Global MX-5 Cup Car Technical Service Bulletin #05-23-2018A

Optional: 2016 & 2017 Global MX-5 Update: Headlight leveling sensor

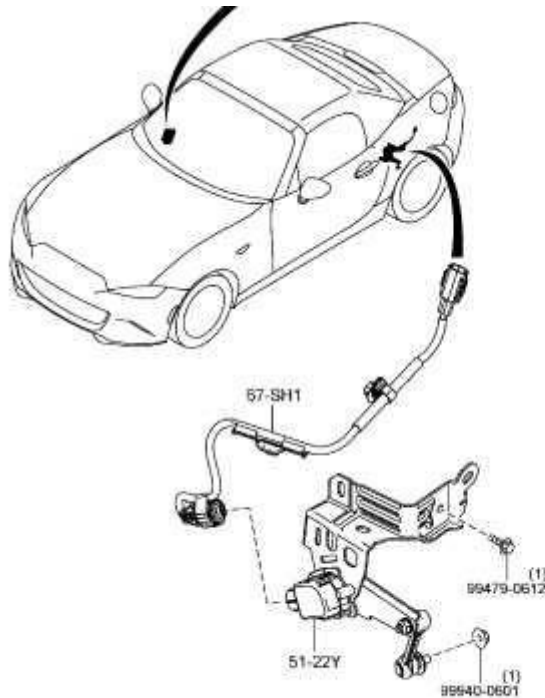
1. The headlight leveling sensor and sensor harness may be deleted.

1. On 2016 and 2017 chassis' is now permitted to remove the headlight leveling sensor (N243-51-22ZA or B) and harness (N243-67-SH0A) from the left rear lower control arm.
